Office Action Summary

10/608,843

DETAILED ACTION***Claim Rejections - 35 USC § 102***

FIG. 1

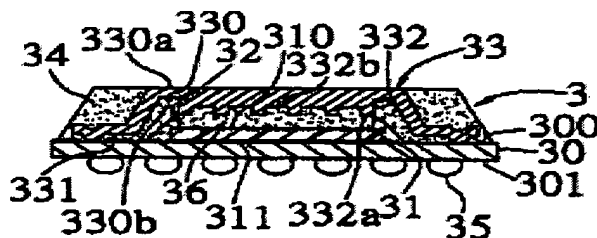
In re claim 1, **Huang** discloses a method for manufacturing a plastic ball grid array package, comprising placing a heat spreader **33** having an upper portion **330a** and a plurality of support arms **331** into a mold cavity, placing over the mold cavity a ball grid array including a semiconductor die **31** mounted on a support surface of a substrate **30** and connected to the substrate, such that lower ends of the support arms contact the support surface **300** of the substrate peripheral to the die; injecting molding material **34** into the cavity; and permitting the molding material to harden to form a mold cap (col. 3, line 53 to col. 4, line 40 and FIGS. 1-7).

In response to Applicants' contention that Huang says nothing as to at least one supporting arm of the heat spreader being affixed to the substrate using a resilient fixative, as recited in the claim, Examiner respectfully disagrees. Applicants are directed to (col. 3, line 53 to col. 4, line 9 and FIG. 1) where Huang discloses that the heat spreader 33 being affixed to the substrate 30 using a resilient fixative.

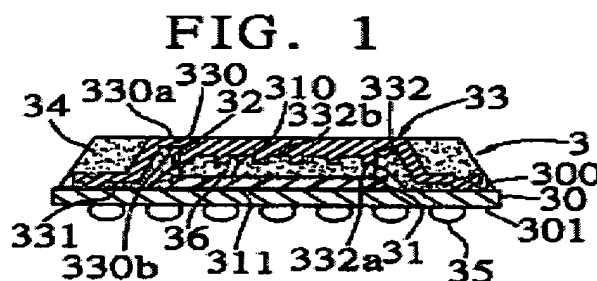
In re claim 10, **Huang** discloses a method for manufacturing a plastic ball grid array package, comprising placing a heat spreader **33** having an upper portion **330a** and a plurality of support arms **331** onto the die support surface **300** of the substrate **30** such that at least one of the supporting arms of the heat spreader is affixed to the substrate using a resilient fixative such as an elastomeric adhesive; placing a mold cavity over the heat spreader; injecting the molding material **34** into the cavity; and permitting the molding material to harden to form a mold cap (col. 3, line 53 to col. 4, line 40 and FIGS. 1-7).
